1 PSE PI P2PIunb Infrastructure requirements completion

Suggested Remedy:

ANNEX 33B [Normative] PSE PI Pair-to-Pair Resistance/Current Unbalance

Fig. 33B-1 PSE PI Unbalance specification and E2EP2PRunb

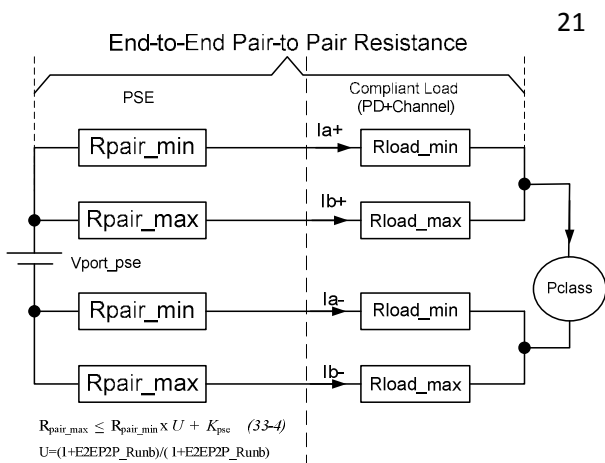
Equation 33-4b is described in 33.2.7.4a, specified for the PSE, assures that E2EP2PRunb will be met in a compliant 4-pair powered system. Fig. 33B-1 illustrates the relationship between PSE PI equation 33-4b and E2EP2PRunb.

20 Fig. 33B-2 direct measurements of effective Rpse_max and Rpse_min

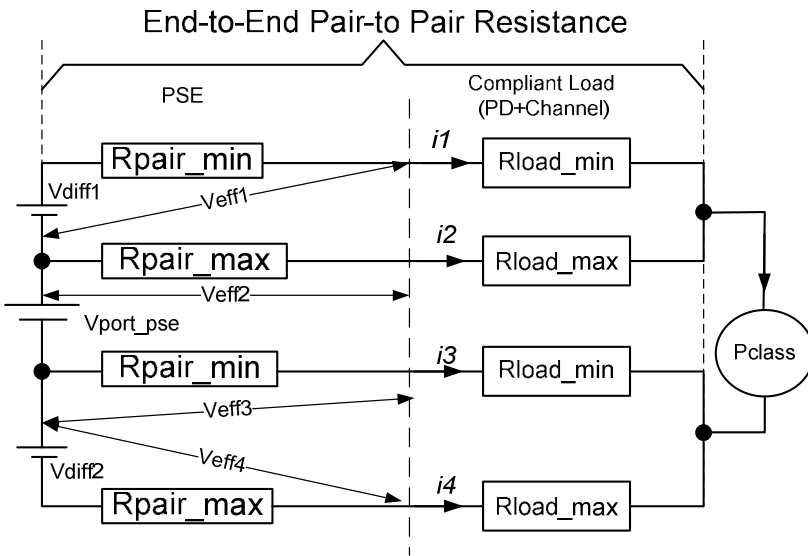
10 If there is access to internal circuits, effective resistance may be determined by sourcing current in each path
11 corresponding to maximum Pclass operation, and measuring the voltage across all components that contribute to the
12 effective resistance, including circuit board traces and all components passing current to the PSE PI output connection.
13 The effective resistance is the measured voltage Veff, divided by the current through the path e.g. the effective value of
14 Rpair_min = Veff1/i1 as shown in Fig. 33-B2.

Fig. 33B-4 Current Unbalance Test Circuit

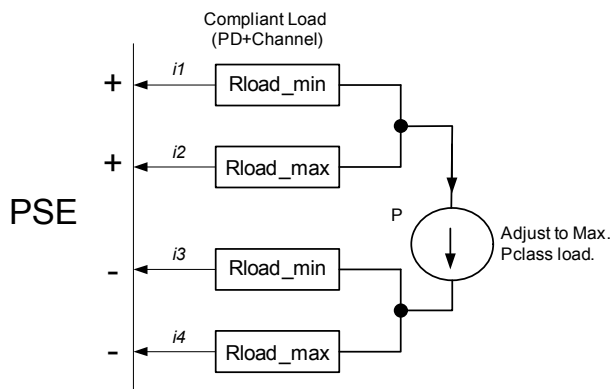
24 Fig. 33B-4 shows a test circuit for the current unbalance measurement.

- 27 1) Use $R_{\text{load_min}}$ and $R_{\text{load_max}}$ from Table Yuval_1
- 28 2) With the PSE powered on, adjust the load for Max. P_{class} power at the PSE
- 29 3) Measure i_1, i_2
- 30 4) Swap $R_{\text{load_max}}, R_{\text{load_min}}$, repeat steps 1 and 2.
- 31 5) Repeat for i_3, i_4
- 32 6) Verify that the current unbalance in each case does not exceed $I_{\text{cont-2P_unb}}$ limit
 33 in table 33-11 item 4a.
- 34 Verification of $I_{\text{cont-2P_unb}}$ in step 6 confirms PSE conformance to Equation 334-b.
